**Manor Road / Richmond**  
Design & Access Statement Landscape  
Addendum 02

## 1.0 Landscape Addendum

Project number	P11559-00-001
Project title	MANOR ROAD
Document title	LANDSCAPE ADDENDUM
Client	AVANTON RICHMOND
Document status	Revision 01
Date of issue	24 July 2020

PLAY STRATEGY PLAN

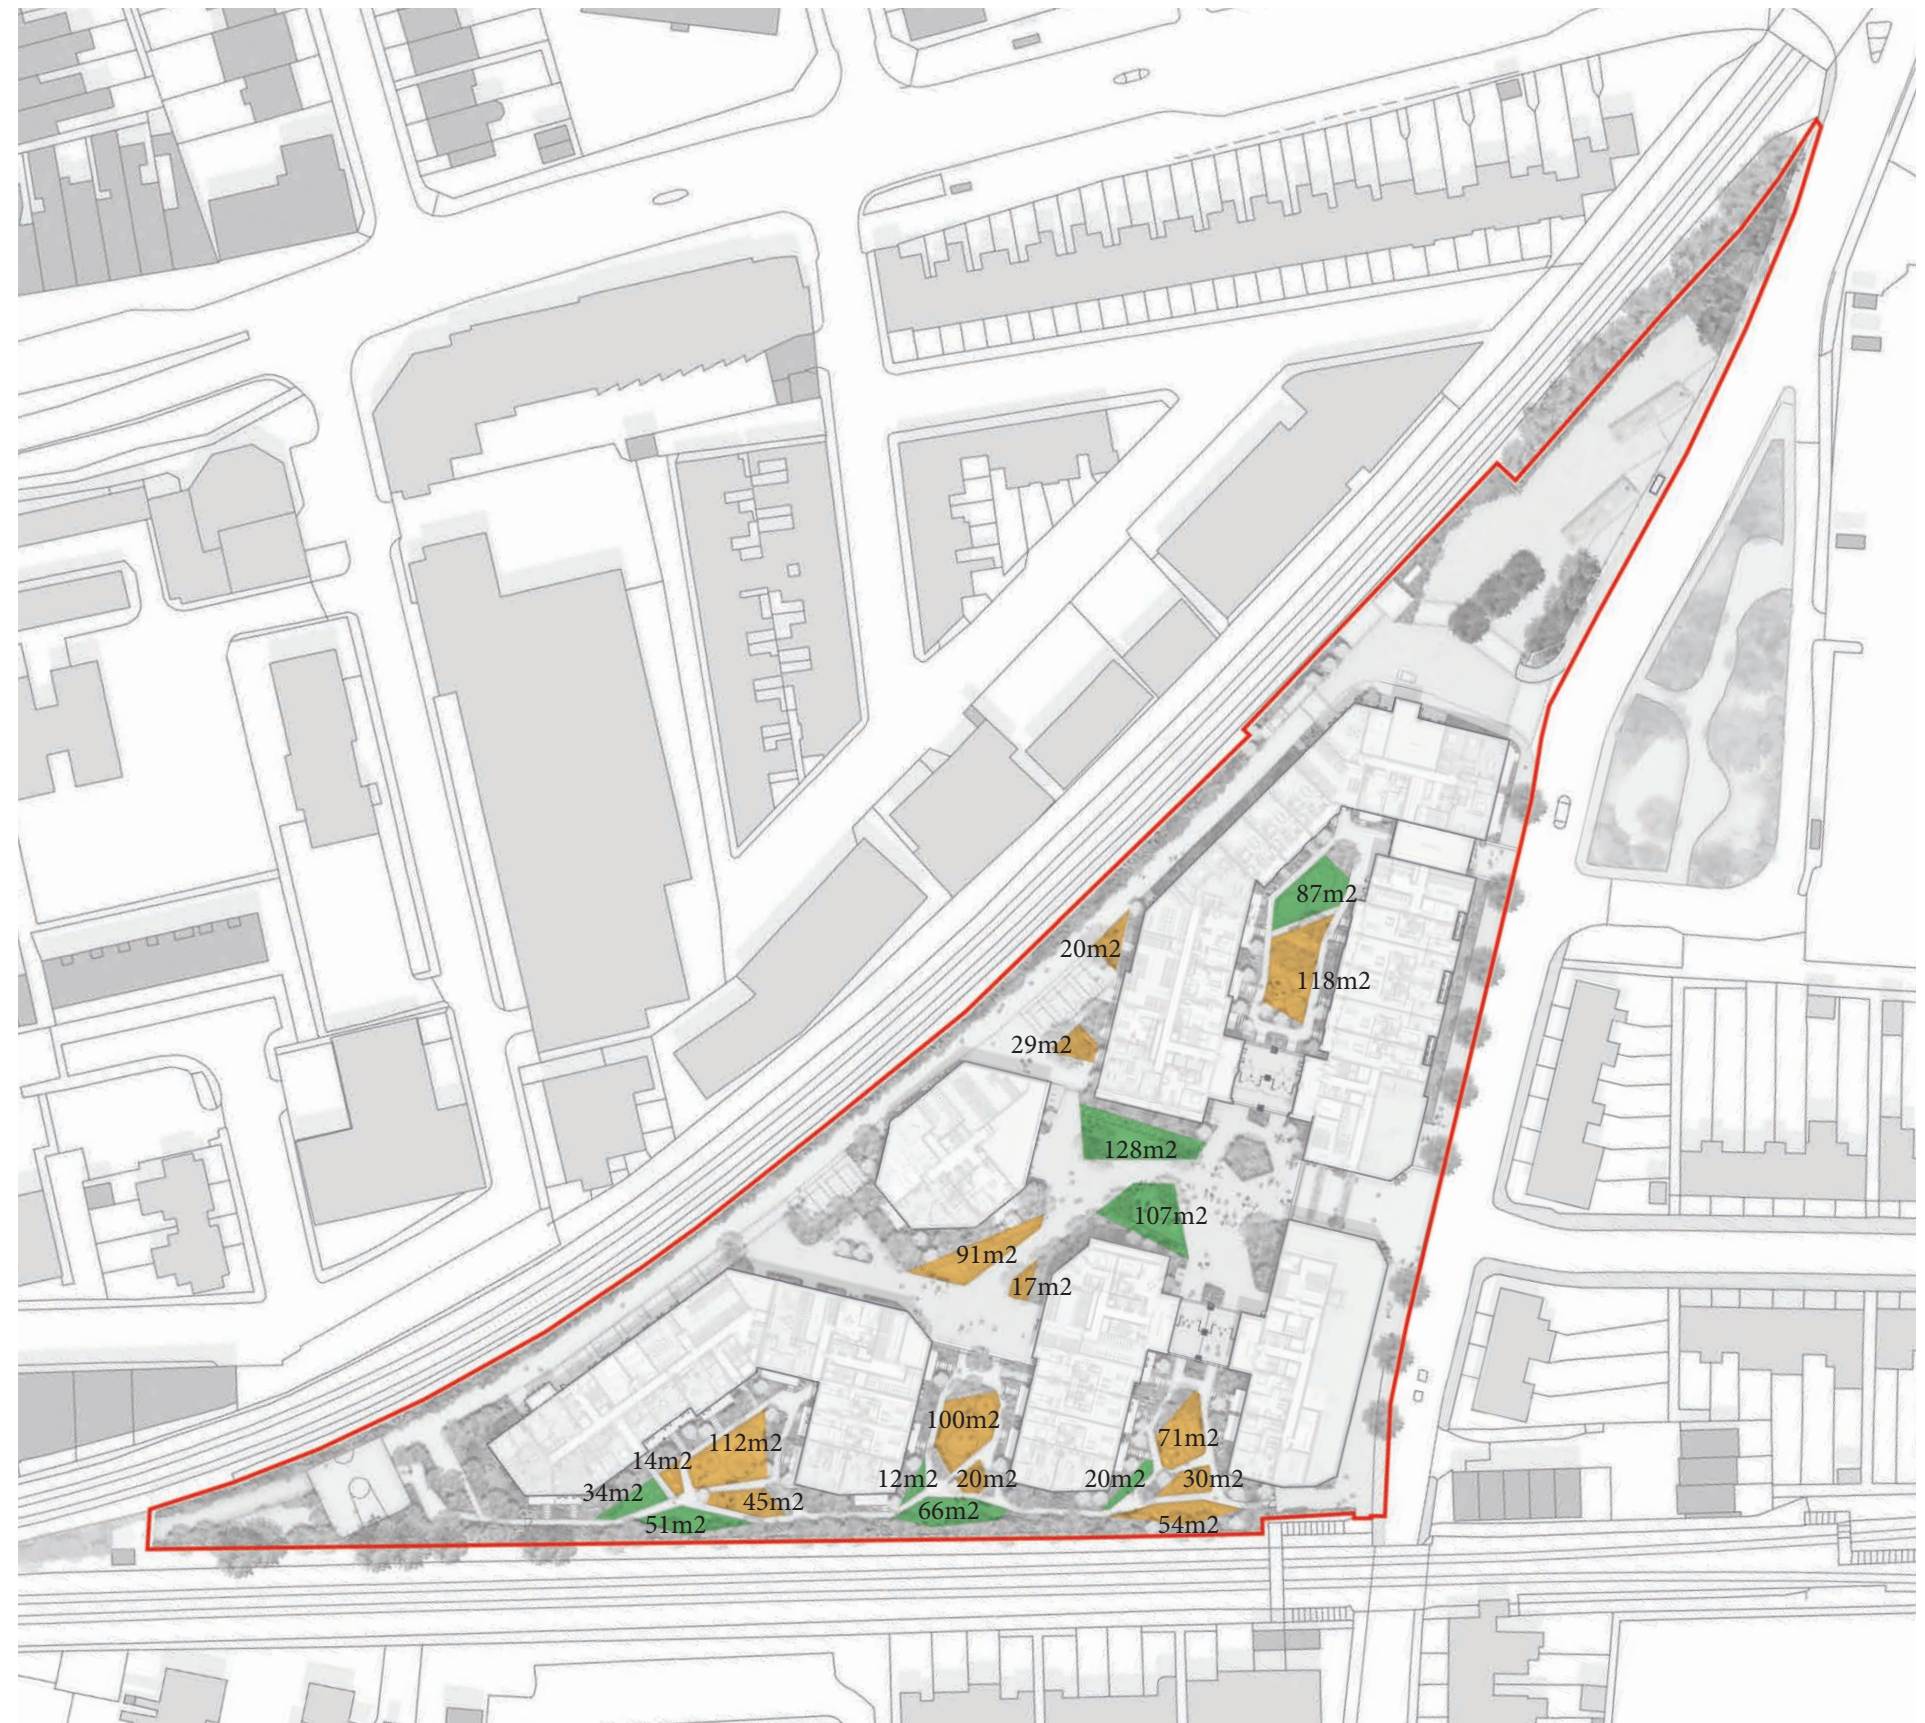
Changes to the unit mix since the November 2019 Amendments have resulted in changes to child yield and play space requirements. These have been recalculated using the current GLA calculator with a slight decrease in overall play space requirement from 1609m<sup>2</sup> to 1479m<sup>2</sup>.

The proposed play space has changed from the previous amendments with the removal of roof top play on Block E. Courtyard spaces have been rationalised to increase play space on the ground floor with the result that provision for 0-4 and 5-11 age groups is marginally less than the requirement. As with the previous scheme, play for older children will be provided by offsite contribution.

URBAN GREENING FACTOR PLAN

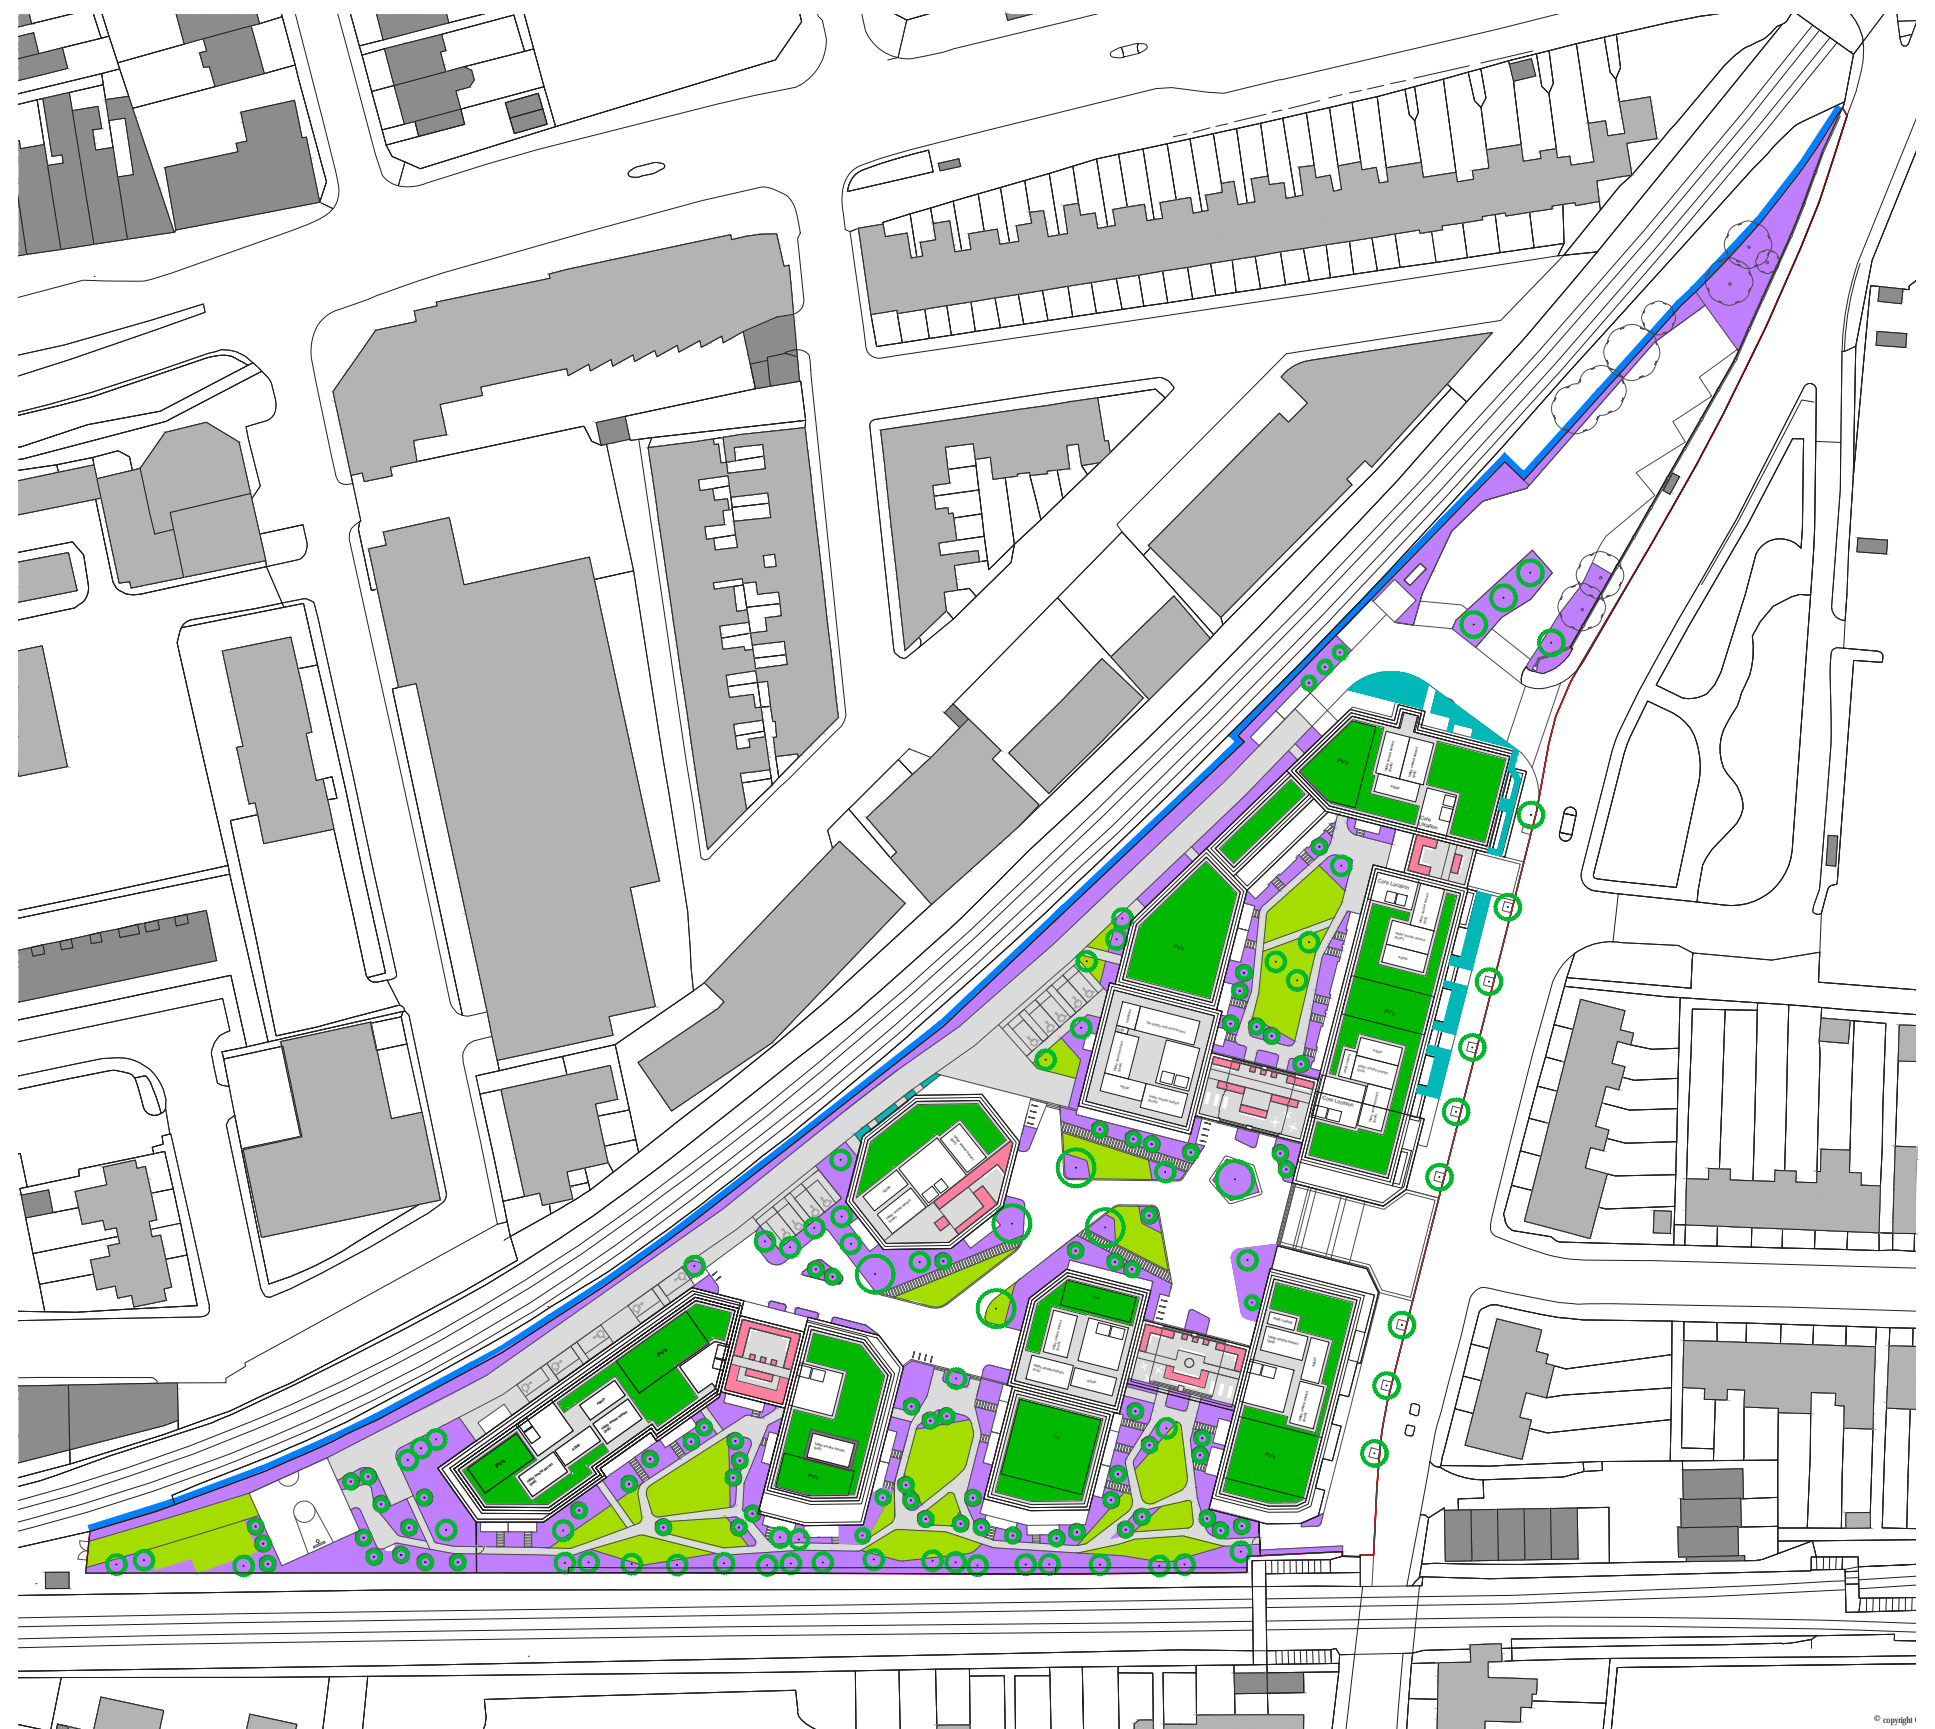
The November 2019 Amendments scheme gave a total UGF factor of 0.347 in comparison with the Mayors interim target score of 0.4 for predominantly residential developments. This has reduced slightly in the Amended Proposed Development to 0.32 due to the retention of the existing bus layover area which is predominantly sealed surface in place of the green roofs formerly included on Block E. Uplifts to existing footways are also included and are by necessity required to be hard surfaced. Elsewhere on site, greening and permeable surfacing is maximised.
